SITE DEVELOPMENT PLAN

Buc-ee's #87

INTERSTATE HIGHWAY 25 AND PALMER DIVIDE RD
MONUMENT, CO 80118

V1_Site Development Plan.pdf Markup Summary

OVERALL SITE DEVELOPMENT PLAN
SITE DEVELOPMENT PLAN
EL PASO COUNTY
PREPARED FOR
BUC-EE'S, LTD.
COUNTY OF EL PASO COLORADO

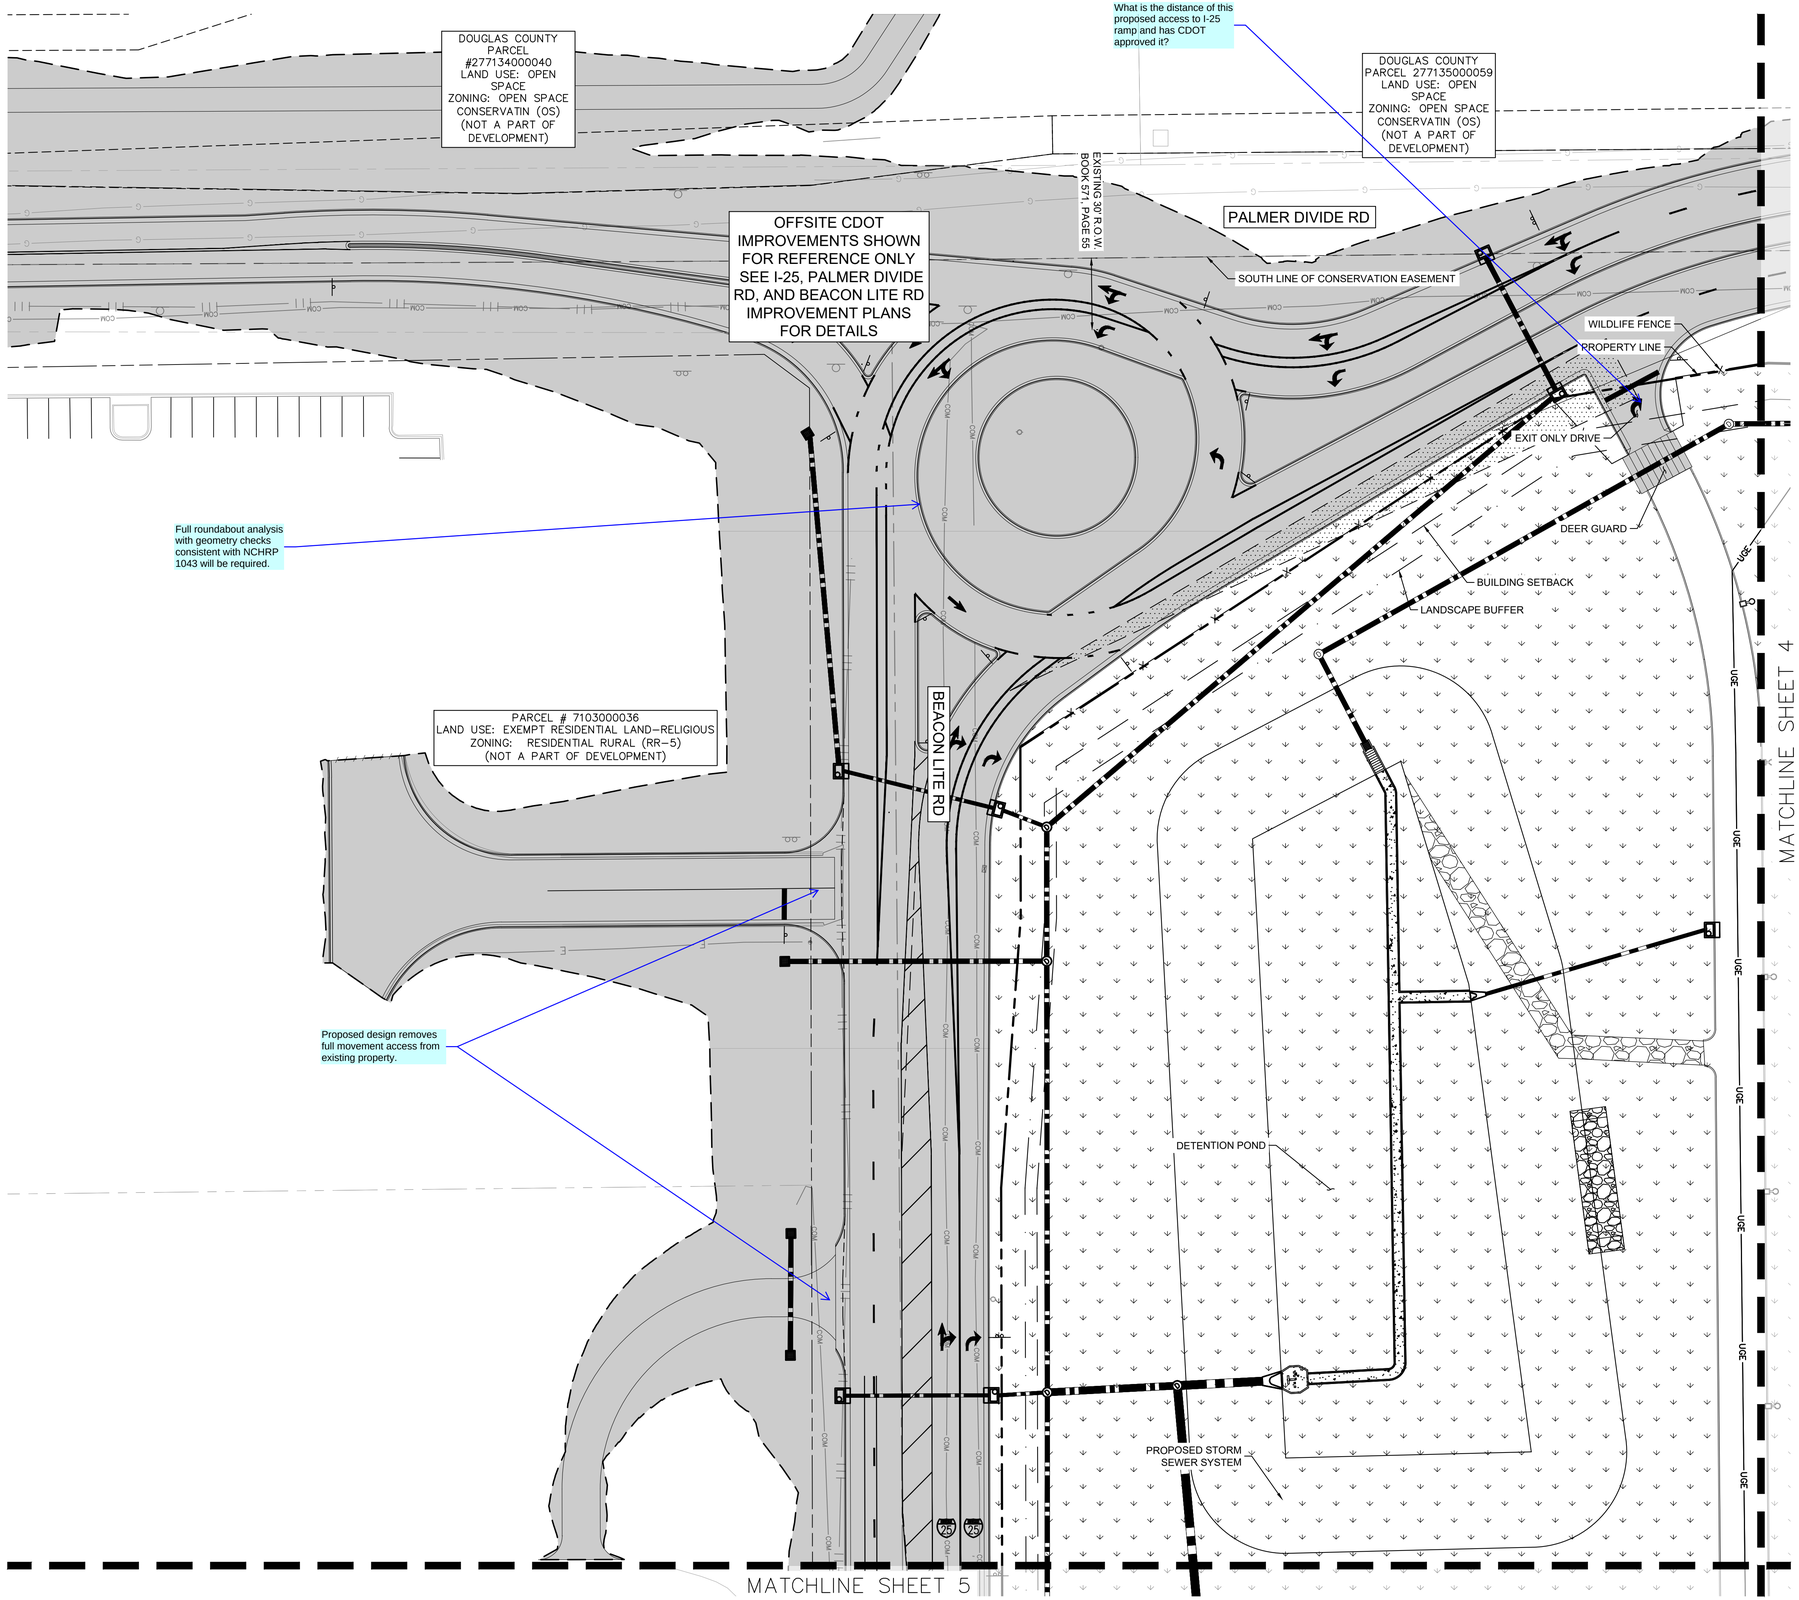
Can you move wording block below so we can see the connection to the south?

If the light gray area is not within the scope of work for this site development plan please remove.

Please remove the parking spaces that are within 100' at a minimum.

Show the Town of Monument (TOM) city limits.

Remove the access drive connection from Beacon Lite Rd and relocated internally if the access is within unincorporated El Paso County. Per ECM 2.4.1.B access spacing shall be separated by a distance equal to the entering sight distance value in Table 2-35.

Coordinate with TOM if the access drive is located within their city limits.

PROPOSED SWALE
WILDLIFE FENCE
DETENTION POND
572.5' SETBACK
PARCEL NUMBER: 7102200014
(NOT A PART OF DEVELOPMENT)
missing land use and zoning like the other parcels shown
RETAINING WALL END

20.0' SETBACK
376.8' SETBACK
142.8' SETBACK
GATE
UTILITY MAINTENANCE ACCESS DRIVE
DETENTION POND
FENCE
500K GALLON GROUND WATER STORAGE TANK SEE DETAIL SHEET 13
please state above ground (per detail on sheet 13)
label and dimension please

SHEET NUMBER
4

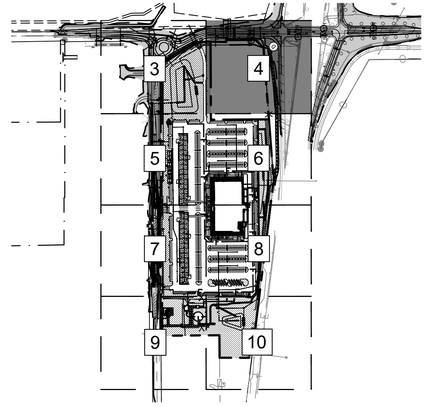
Show CDOT's A-line.

SHEET NUMBER
9

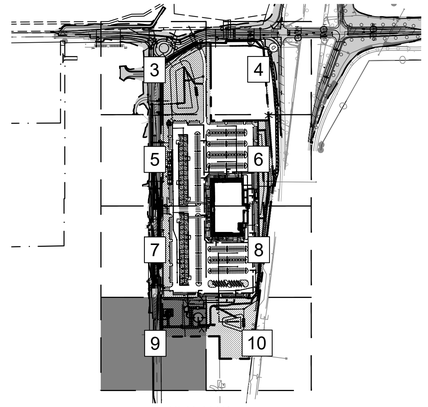
Show and label the Town of Monument city limits.

An approval of location application may be needed if it is determined this does not meet Appendix B of the LDC

Please include this information to this plan set. I could not find separate the utility set for site design

RETAINING WALL DETAILS
SITE DEVELOPMENT PLAN
EL PASO COUNTY
PREPARED FOR
BUC-EE'S, LTD.
COLORADO
COUNTY OF EL PASO

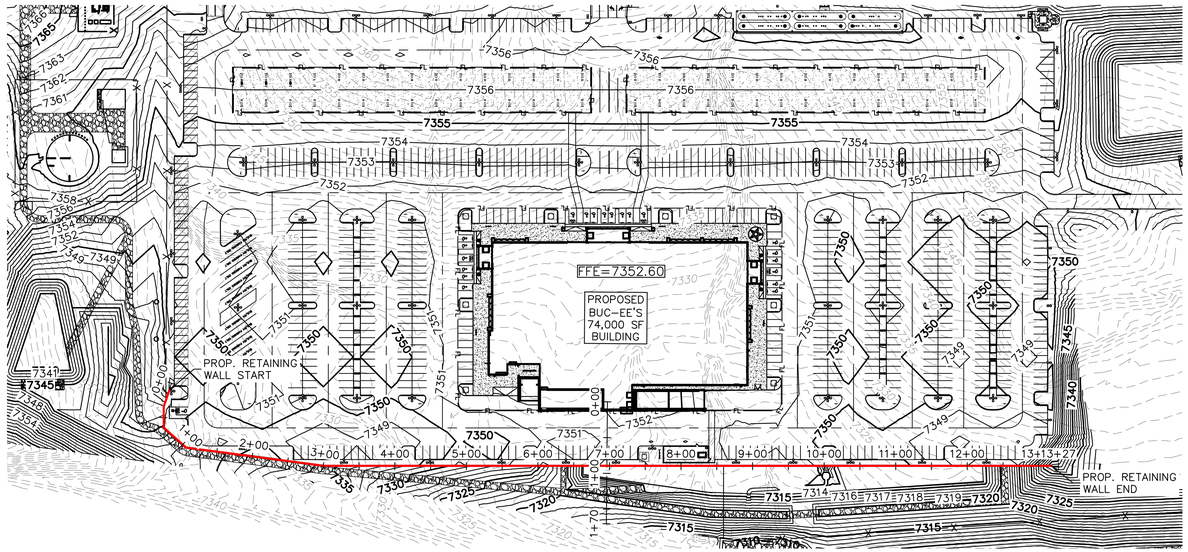
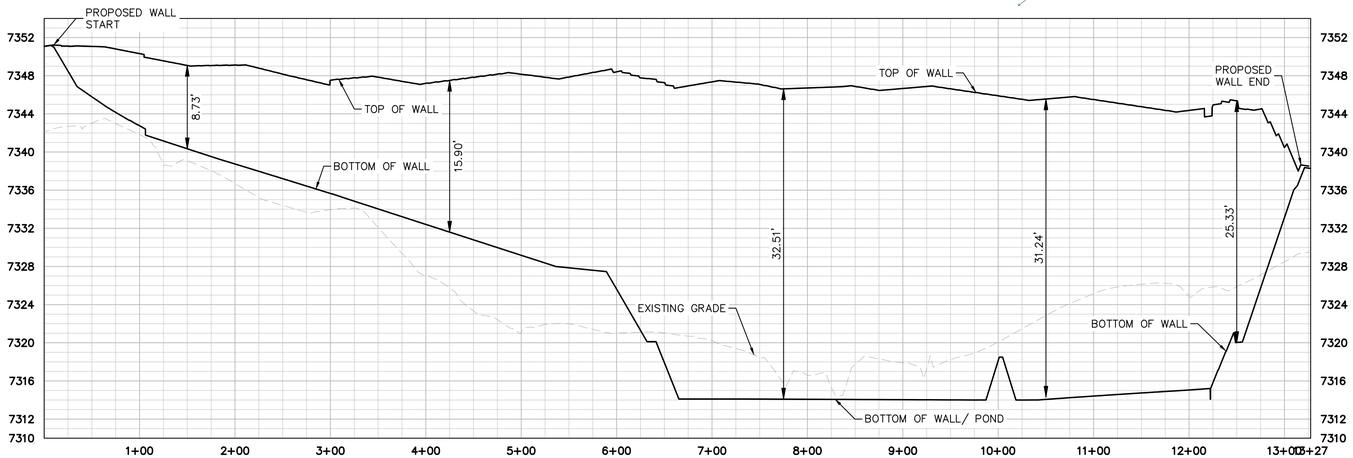
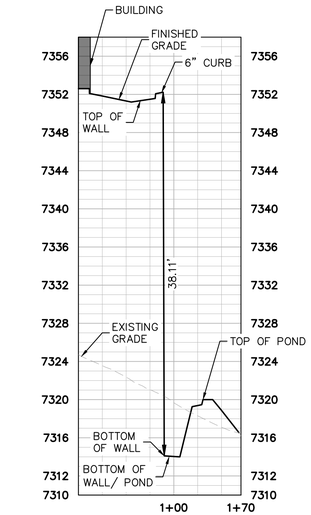
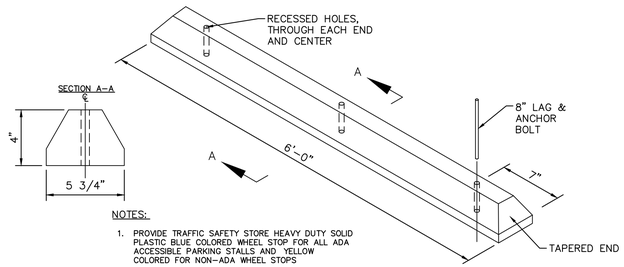
This sheet is included in construction drawings. Suggest removing it from one of the 2 plan sets. Only needs to be in one set. Minimizes chance of conflicting information. Suggest leaving it in CD plan set.

Informational comment: Per the LDC retaining walls over 4 feet will require a building permit.

TANK DETAIL

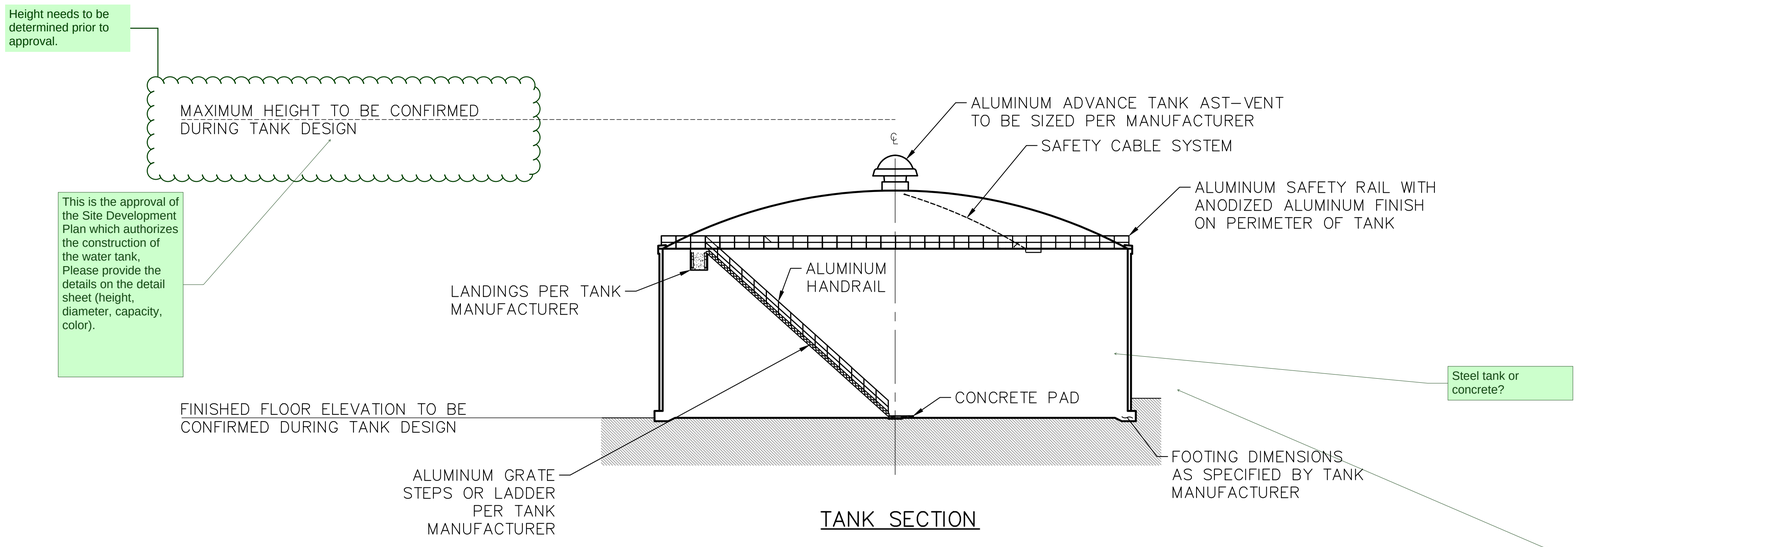
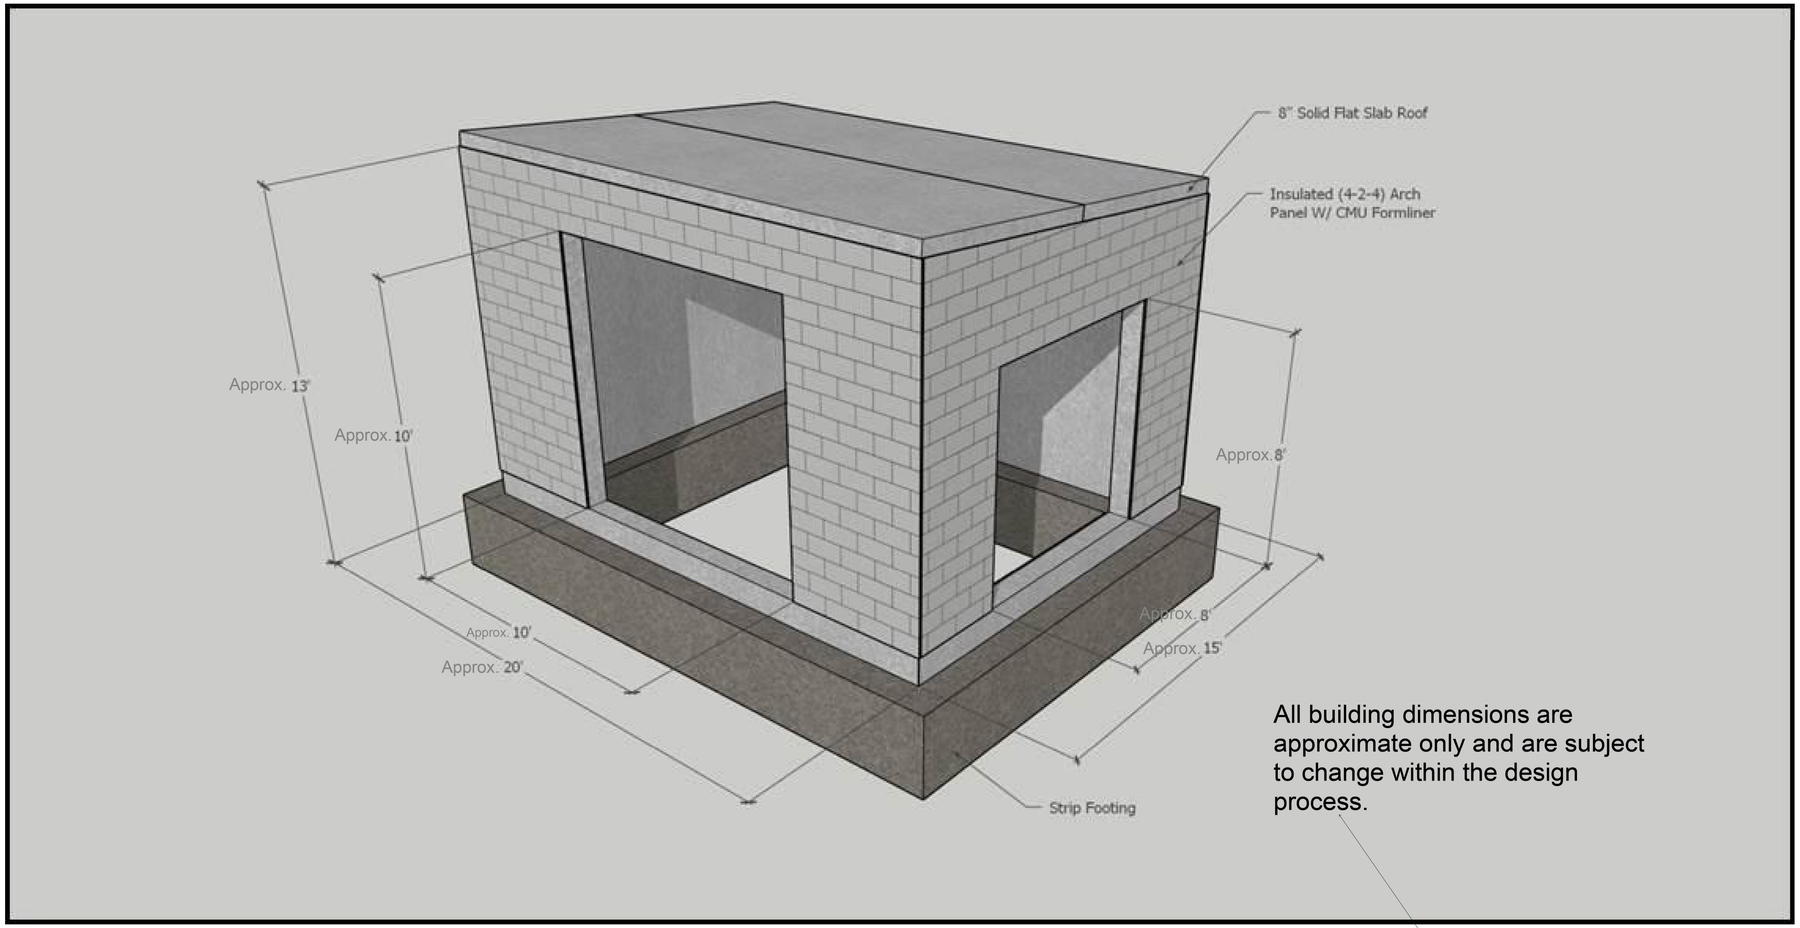
Add details for pump
station please

This is the approval of the Site Development Plan which authorizes the construction of the water tank, Please provide the details on the detail sheet (height, diameter, capacity, color).

CHLORINATION BUILDING DETAIL

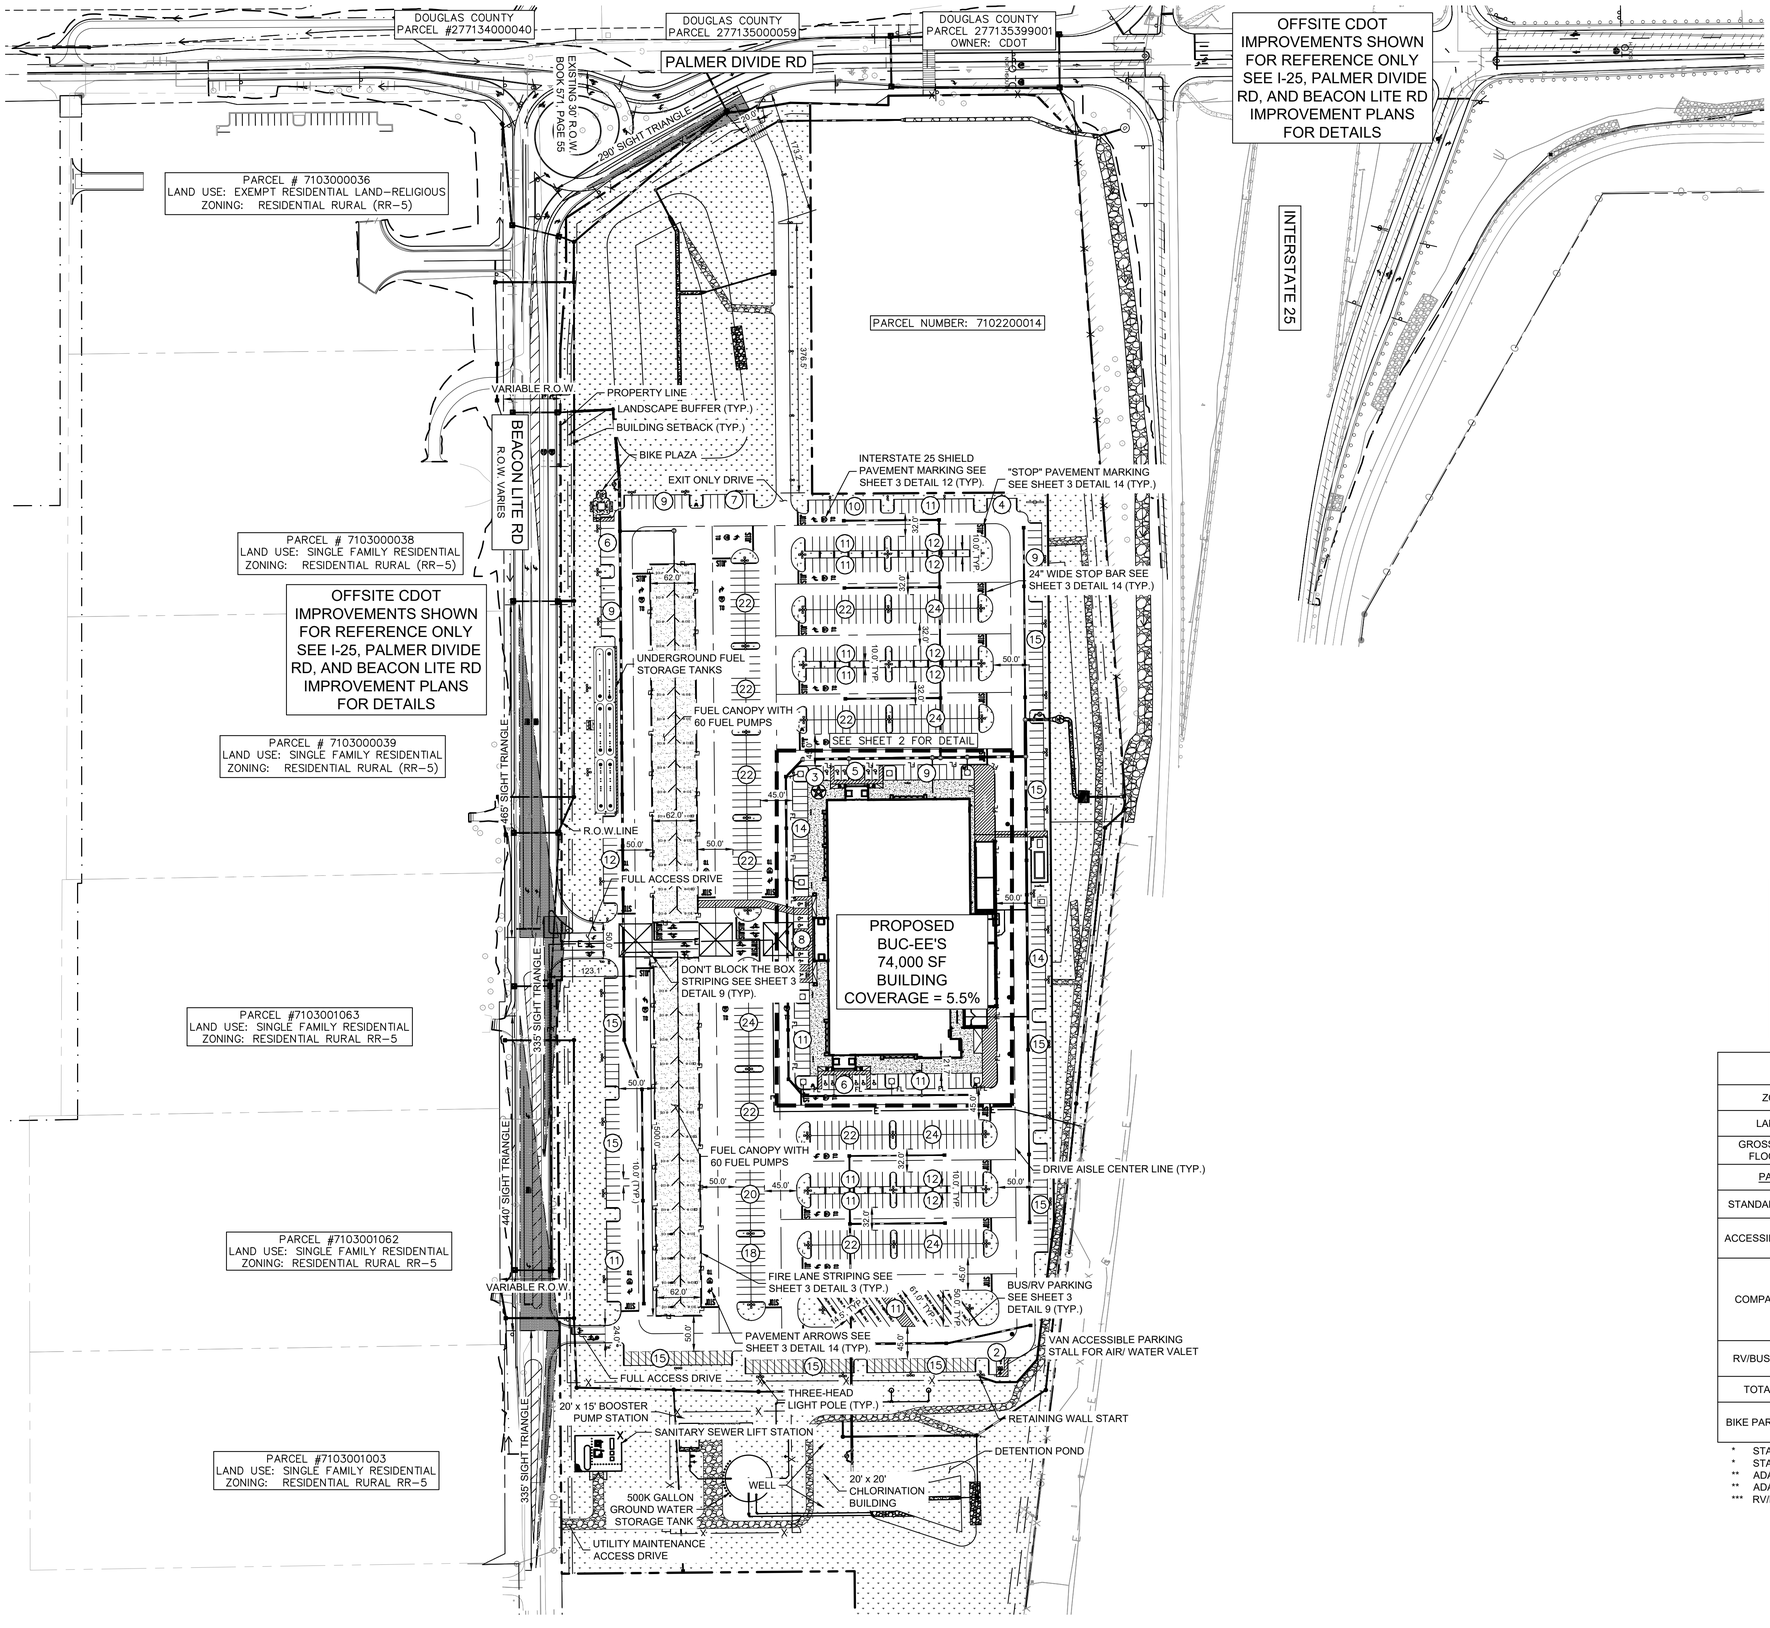
Please provide the final version (capacity- dimensions height & architectural elevations) for this review and approval of the site development plan
